Introduction

This errata sheet provides updated information on enhanced configuration devices—EPC4, EPC8, and EPC16—which are used to configure SRAM-based programmable logic devices (PLDs). This document addresses known issues and includes methods to work around the issues.

Figure 1. DATA and DCLK Signals Generated by Enhanced Configuration Devices

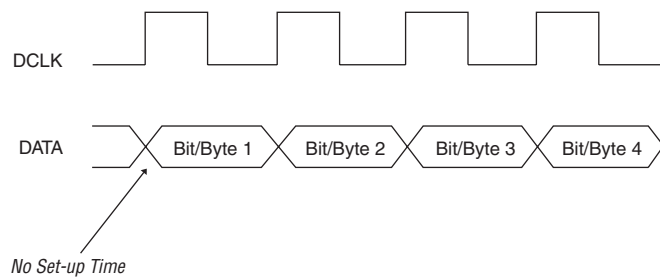
The problem is due to a set-up time violation of the DATA signal. The enhanced configuration device generates the DATA and DCLK signals so that they arrive at the PLD simultaneously.

The PLD requires a set-up time of 10 ns. However, since the DCLK and DATA signals transition simultaneously, the set-up time at the PLD is actually zero. [Figure 1](#) shows the DATA and DCLK signals generated by enhanced configuration devices.

Figure 3. DATA Latches on Second Rising Edge of DCLK after DATA Path Delay

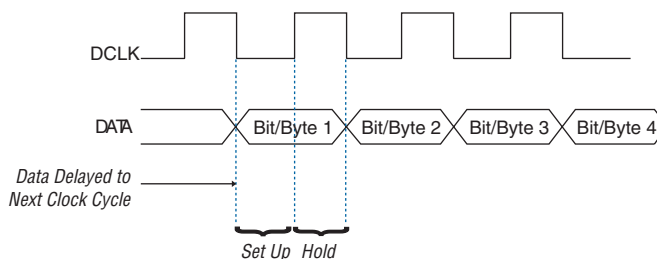
After inserting the delay, the DATA transition would shift to the right so that the first bit or byte of data would be latched on the second rising edge of DCLK, as shown in Figure 3. This shift meets the required set-up time for the DATA signal.

The delay is created by a resistor-capacitor network. The resistor is added to the circuit and the capacitance is provided by the board trace. The RC combination should be chosen such that the path delay is equal to 10 ns.

A typical combination would use a 100- to 200- Ω resistor with a trace length of four inches between the DATA pins of the enhanced configuration device and the PLD.
